**A: Existing MUTCD Bicycle Route Signing System**

**B: Proposed Bicycle Route Signing System**

# Request to Experiment

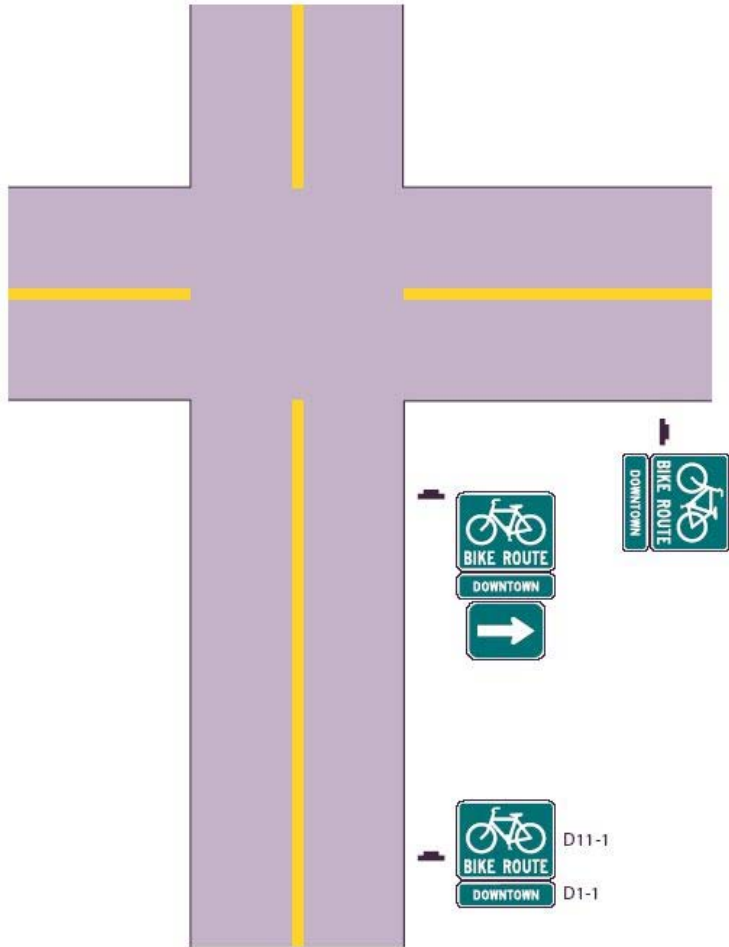
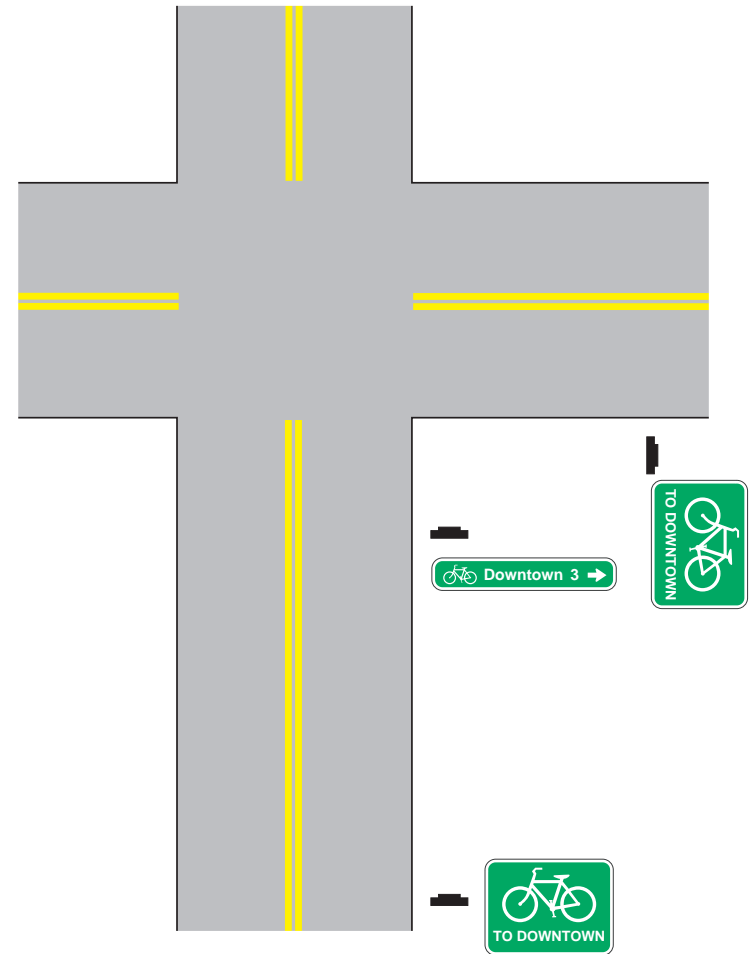
Upon reviewing the application of this on-street route signage system to Chicago, CDOT found that the requirements set in the current MUTCD (2003 edition) do not best address the needs of Chicago streets. The current MUTCD route signage system works well in areas where only one bicycle route exists (See Attachment 1A: MUTCD Figure 9B-6). Chicago, however, frequently has locations where 2 or 3 routes intersect. When multiple routes intersect, the MUTCD signage system can result in both sign clutter at an intersection and higher construction costs for the project. Attachment 2A provides an example of the MUTCD signage system with three on-street routes at the same intersection.

CDOT proposes to use the D1-1b Bicycle Guide Sign in place of the D11-1, D1-1, M7-1 sign assembly shown in the MUTCD (see Attachment 1B). Using the D1-1b sign will decrease costs and sign clutter at the intersection because all pertinent user information is located on one sign instead of three. This allows the user to quickly comprehend the sign information and then return focus to the roadway.

# Attachment 3: D1-1b

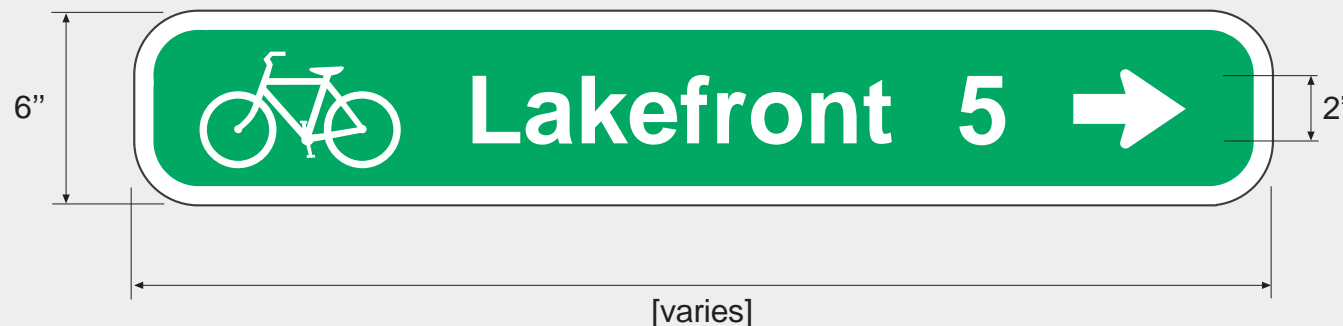
Although the Bicycle Guide Sign design proposed by CDOT varies from the D1-1b Bicycle Guide Sign illustrated in section 9B.20 of the MUTCD, it is consistent with MUTCD guidelines.

? The Bicycle Guide Sign design proposed by CDOT includes a bicycle symbol added to the principle legend. This is allowed under section 2D.07 of the MUTCD.

? The Bicycle Guide Sign design proposed by CDOT includes a combination of lower-case letters with initial upper-case letters. This is allowed under section 2A.14 of the MUTCD. (Note that section 9B.02 of the MUTCD states: “Except for size, the design of signs for bicycle facilities should be identical to that specified in this Manual for vehicular travel.” Chapter 2 can thereby be applied to the Bicycle Guide Sign. See Figure 2D-1 of the MUTCD for an example of a destination guide sign with a symbol added to the principle legend.)

# Attachment 4: D11-1 Modified

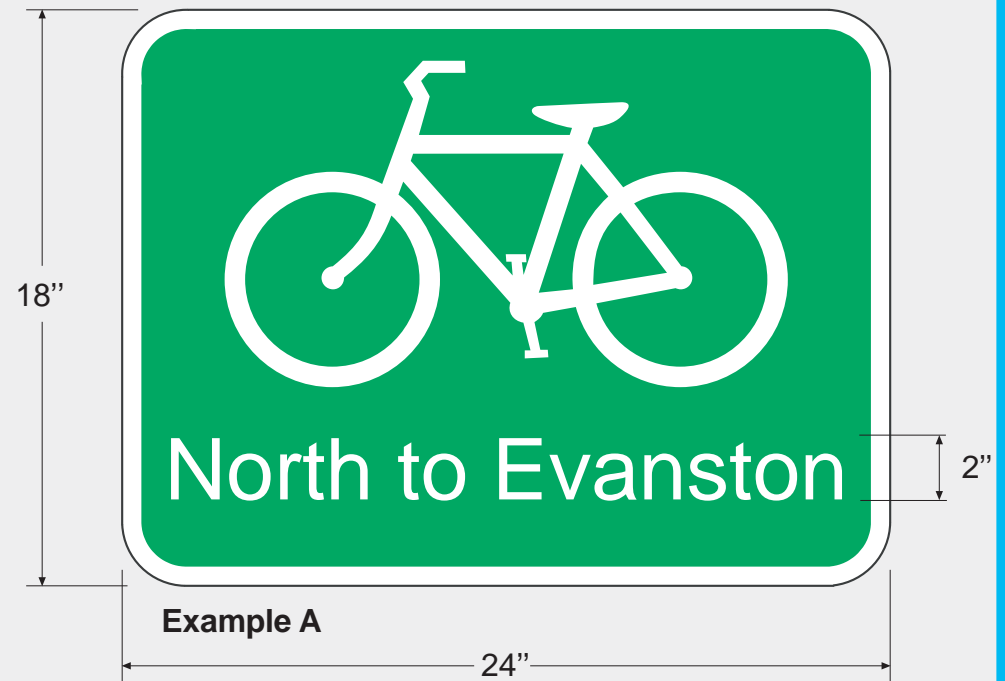
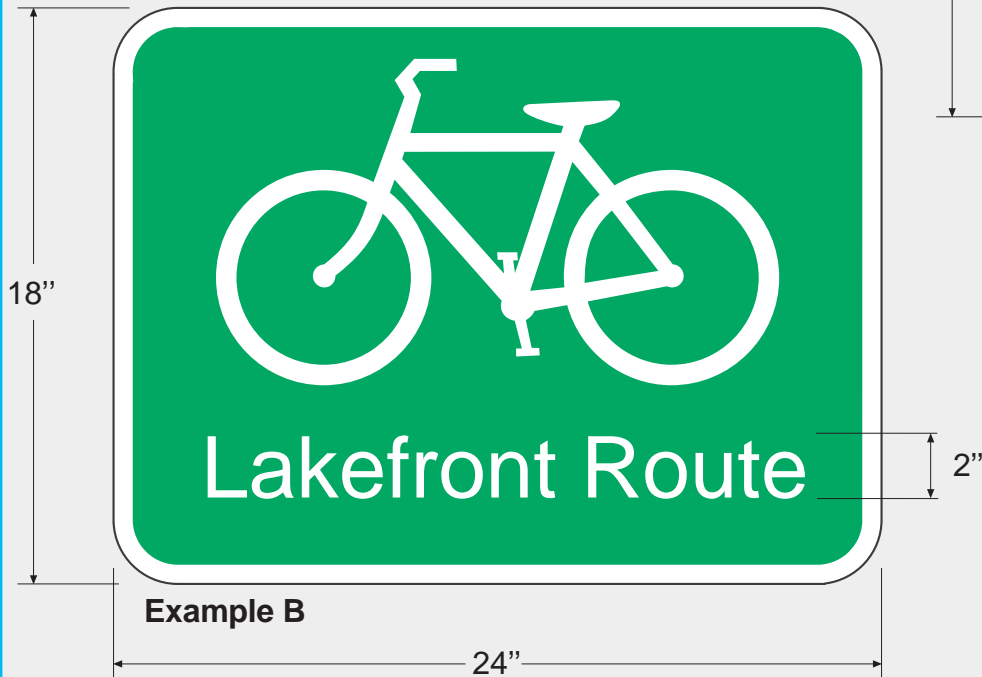
The proposed D11-1 Modified sign (Attachment 4) removes the text “BIKE ROUTE” and replaces it with specific destination information. Adding the text “Bike Route” to the D11-1 bike route sign is redundant. By replacing the “Bike Route” text with specific destination information, the Modified D11-1 will replace the D11-1 and D1-1 sign assembly. This reduces sign clutter and cost. It may also increase user comprehension of the sign by reducing the amount of text and incorporating all messages into one sign instead of two.
